Wiltshire Council Planning Consultation Response

URBAN DESIGN

Application No: PL/2026/03045

Site Address: Land off Damask Way, Warminster

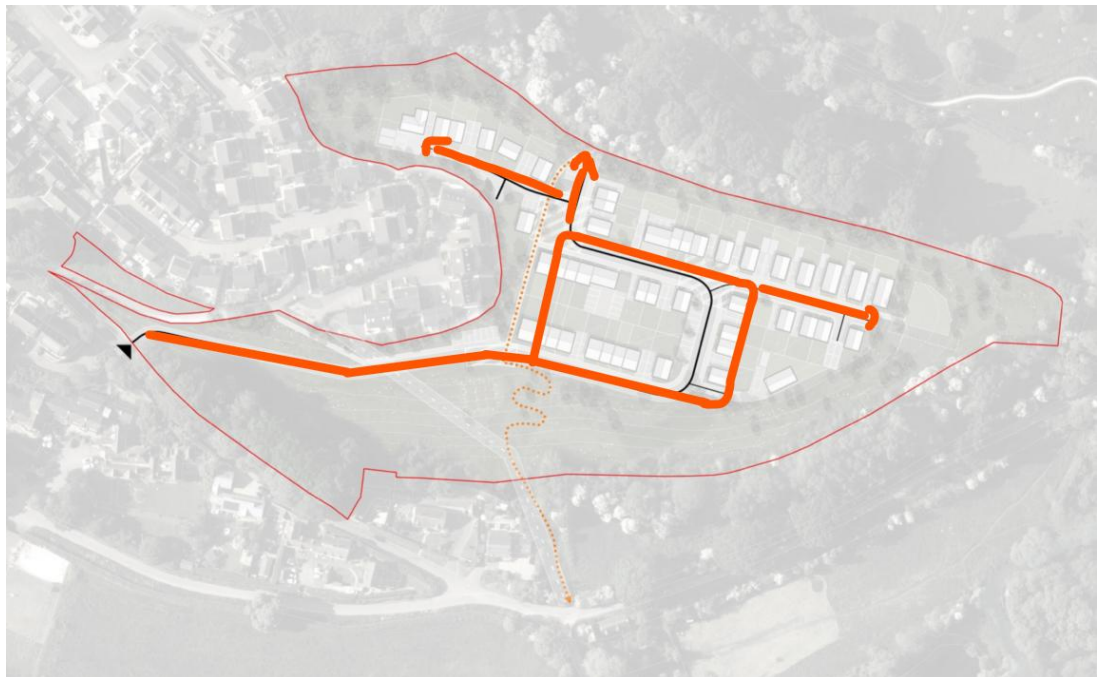
- 1) The generally straight alignment of the streets is welcomed as it improves legibility in developments, however, concerns remain regarding the overall movement structure.

The illustrative masterplan is largely based on a branching cul de sac arrangement with a number of terminating streets and private drives. Several of these terminate beyond the view of the principal route through the site. This approach is contrary to Wiltshire Design Guide paragraph 5.1.8, which advises that cul de sacs should be short and that their ends should be visible from a through route.

The arrangement also raises concerns in respect of Core Policy 57, particularly relating to legibility and ease of movement. The street hierarchy is weakened by the frequency with which routes terminate rather than forming connected streets. The resulting layout relies heavily on turning heads and communal bin collection points.

Building for a Healthy Life identifies disconnected street patterns and excessive use of turning heads as examples of 'what red looks like'. By contrast, 'what green looks like' promotes connected and permeable movement networks.

It is recommended that opportunities are explored to create a more connected layout. A loop road arrangement is one possible solution and may assist in improving navigation and strengthening the street hierarchy. Please see markup below.
